CONNECTION ASSESSMENT & APPROVAL PROCESS

Project: Kingston-Gardiner TS: Establish a Second 230kV DESN

CAA ID No. 2003-EX176

Kingston-Gardiner TS - Establish a 2nd 230/44kV DESN Station

DIAGRAM 1

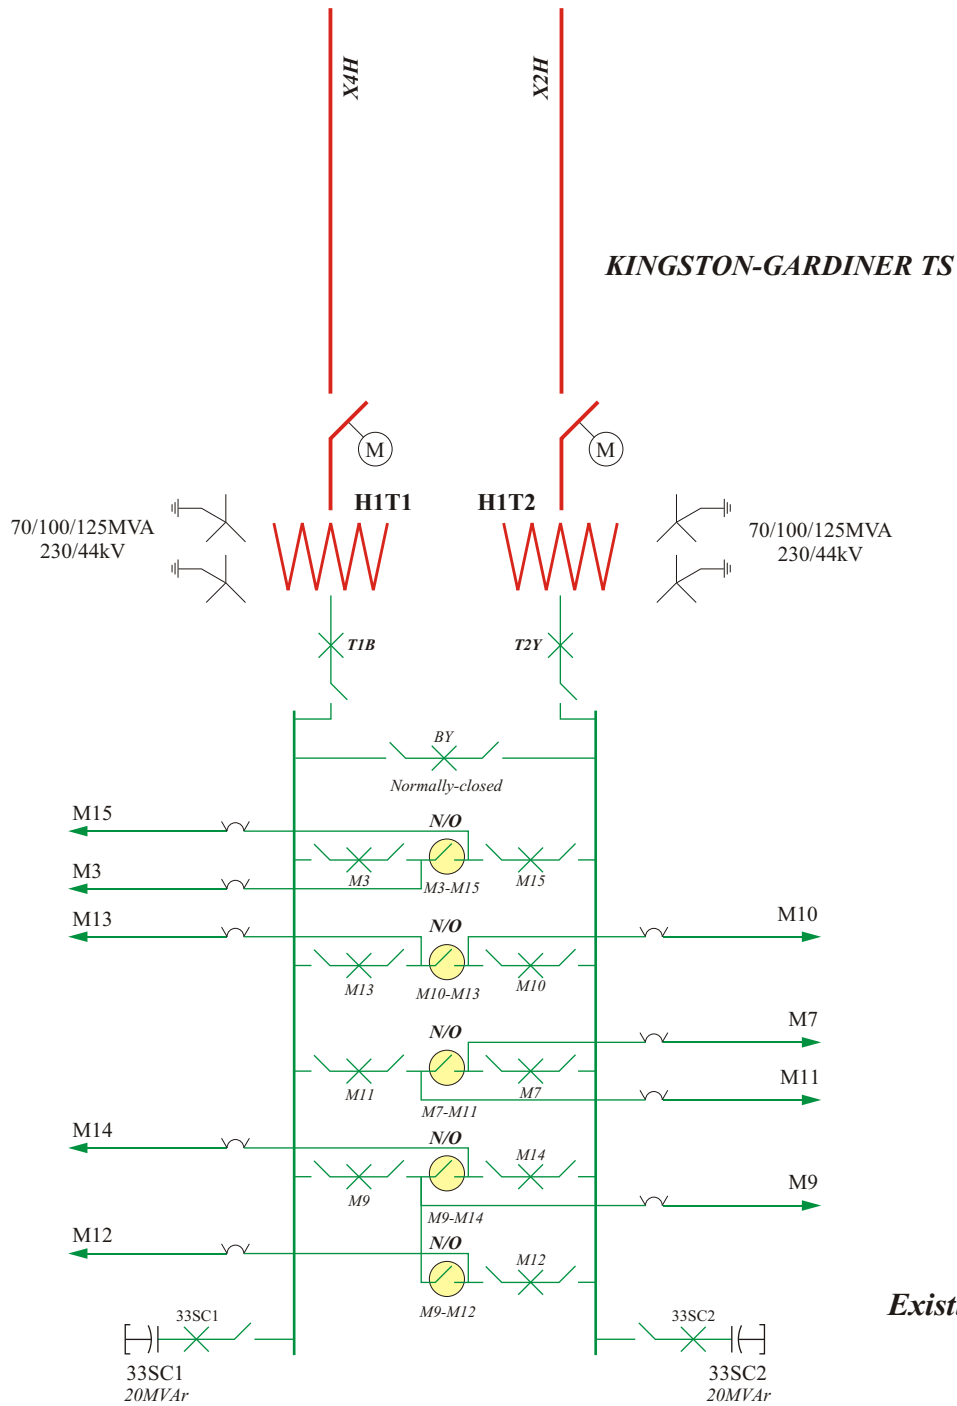
Diagram 1 shows the existing facilities in the Lennox GS to Hinchinbrooke TS corridor and the proposed connection arrangement for the second DESN station.

The 230kV circuits between Lennox GS and Hinchinbrooke TS are used primarily for accommodating a portion of the output from the four generating units at Lennox GS (2 x 550MW & 2 x 575MW) and they would only be expected to be heavily loaded under contingency conditions involving the 500kV circuits between Lennox GS and Hawthorne TS.

Even under these conditions, with all four units at Lennox GS operating at full output, the flows on the four circuits to Hinchinbrooke TS would be well within their continuous ratings (flows of approximately 250MVA per circuit, compared to a rating of approximately 460MVA)

The additional load at the Kingston-Gardiner TS could therefore be accommodated with no adverse impact.

**Proposed Arrangement of Kingston-Gardiner TS
with a Second DESN Station**

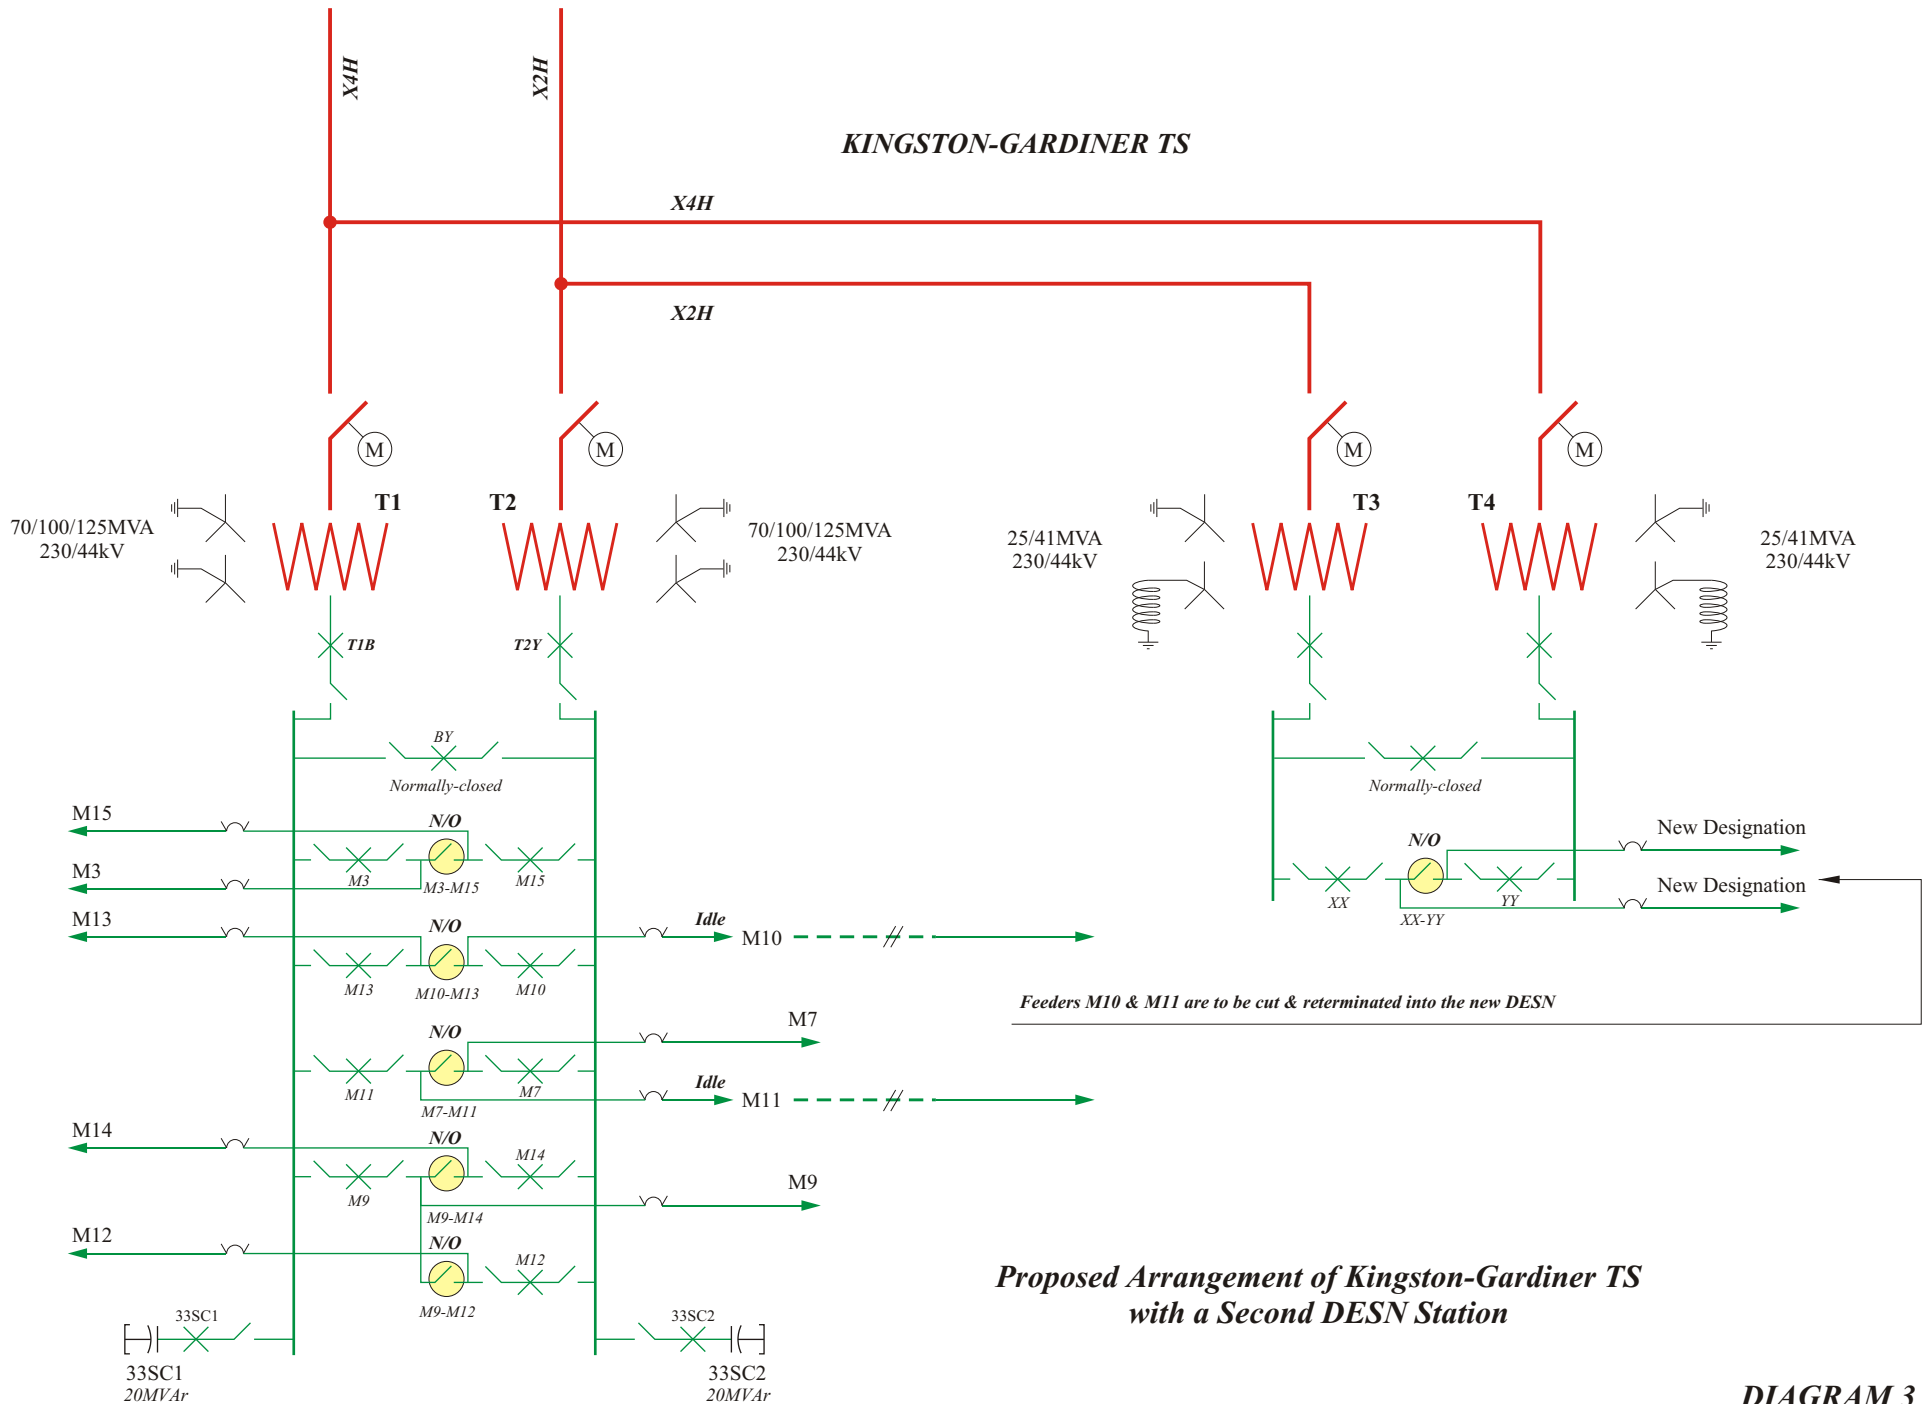
The new facilities that it is proposed to install at Kingston-Gardiner TS are shown in Diagram 3.

Diagram 3 provides details of the 44kV busbar arrangement at the new DESN station, with a normally-closed bus-coupler breaker interconnecting the two 44kV busbars. The development is to include two 44kV feeder positions and these are to be occupied by the feeders, M10 & M11 to Dupont Canada Inc., relocated from the existing DESN station.

Surge arresters are to be installed on the HV & LV terminals of each step-down transformer.
